QUALITY ASSURANCE -- NON-CONFORMANCE REPORT

Report No: NCR-000546

Reference Description: Side Panel Flatness, Segments 6BE/6CE

Job Name: SAS Superstructure
Document No: 05.03.06-000507

Reference Description: Side Panel Flatness, Segments 6BE/6CE

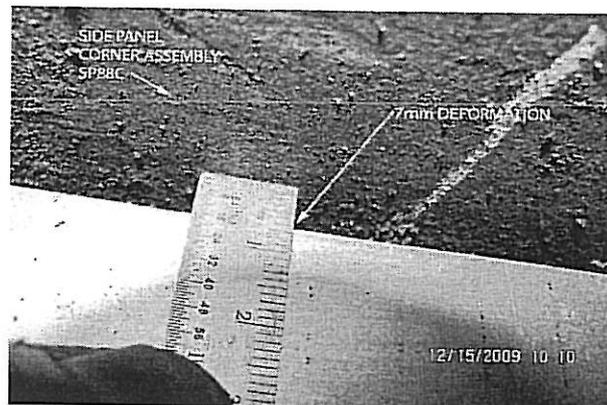
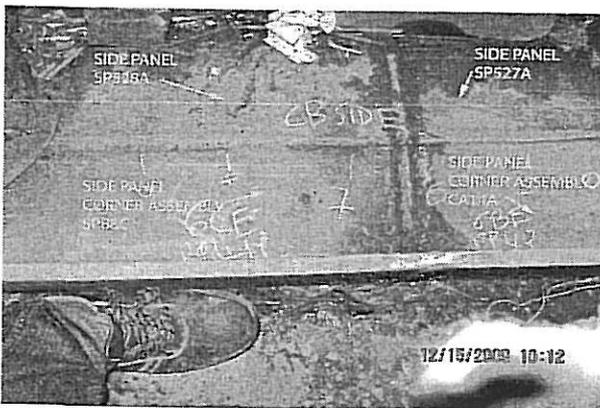
During a random visual survey inspection for flatness of Corner Assembly (CA) to Side Panels (SP) of the Transverse Splice for segment 6BE to segment 6CE between PP43 and PP44, the Caltrans Quality Assurance (QA) Inspector verified out of flatness measurements at the intersections of CA to SP welds. The maximum out of flatness measurement was 7mm, utilizing a 600mm straight edge and the maximum allowable tolerance is 5mm. Additional information identifying this non-conformance is listed below.

- 1) Side Panel 6BE plate is identified as: SP527A
- 2) Side Panel 6CE plate is identified as: SP528A
- 3) Corner Assembly 6BE plate is identified as: CA14A
- 4) Corner Assembly 6CE plate is identified as: SP88C
- 5) Transverse weld splice for 6BE to 6CE is identified as: OBE6C-002
- 6) Horizontal weld splices are identified as: SEG030A-010 and SEG032B-025

Standard Specifications July, 1999: Section 55-3.17 WELDING; "The flat side of all butt welded joints shall not deviate from flatness by more than 5 mm in a length of 600 mm centered over the weld joint."

Submit a repair procedure to correct flatness to within the specified tolerance to the engineer for approval. A response for the resolution of this issue is expected within 7 days.

Heat Straightening Record(HSR1)

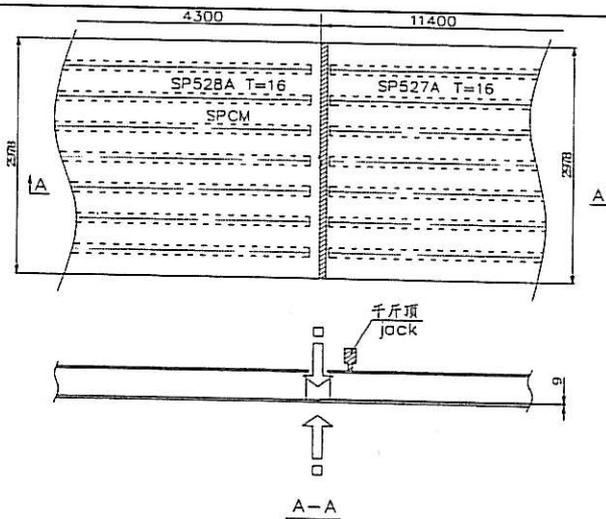
情况描述 Description of Condition

Welding distortion 焊接变形

Welding distortion 焊接变形

Flame Straightening by oxygen acetylene

After finishing heat straightening, the weld of the heat area shall perform NDT according to the approved shop drawing

Control current, voltage and weld speed according to relevant WPS. If necessary anti-deformation or hold down device can be added.

最高温度(Maximum temperature): <650°C

注: 最大变形量约 9mm, 校火宽度50~100mm.

NOTE: the max deformation is about 9mm, heat straightening the width is 50~100mm.

焊缝返修位置示意图：
Draft of welding discontinuity:

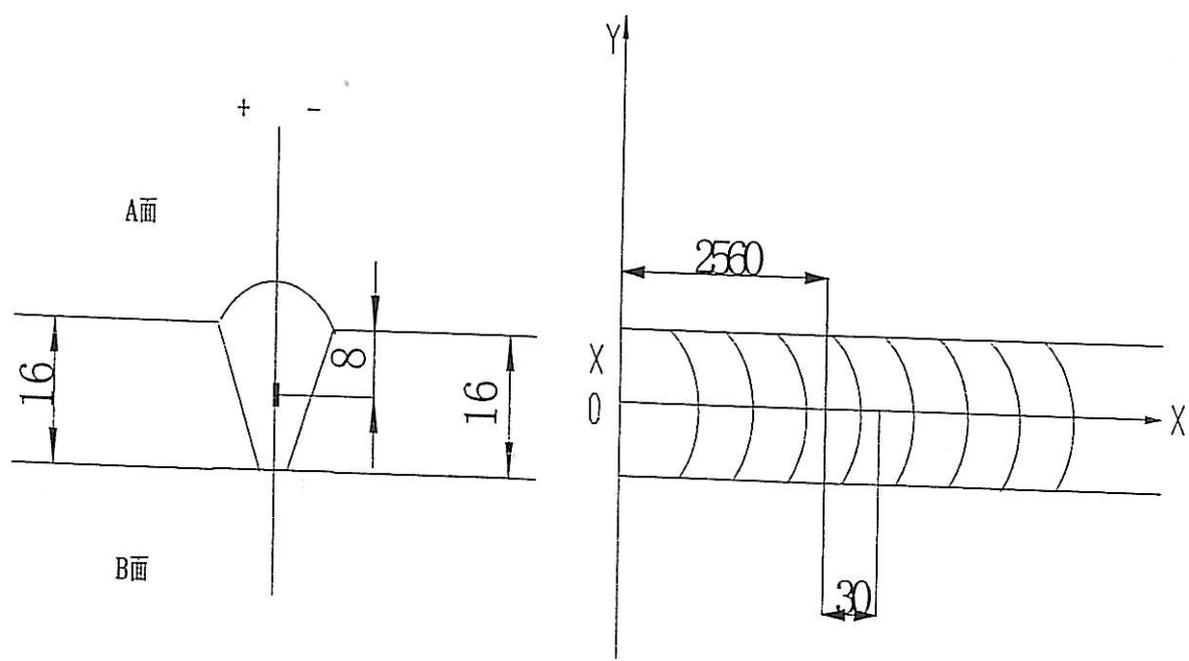
Rejected indication found by ultrasonic inspection is less than the maximum allowance aggregate length.
(UT探伤发现的缺陷总长度小于最大允许长度。) SEG030A-010

- 1、焊道未及时处理干净。
1. Did not clear the weld pass completely in time.

1. Gouge or grind from nearer side from metal edge ($D \leq 0.65T$, "D" is depth of defects, "T" is thickness of metal) to remove all defects;
2. Follow repair WPS for joint preparation, preheat, and weld deposit;
3. Verify with VT no defects remain in the weld joint prior to welding;
4. Grind the repaired area flush with base metal or the adjacent weld;
5. Check the welds according to the working drawings.

1. Improve monitoring of welding and interpass cleaning.
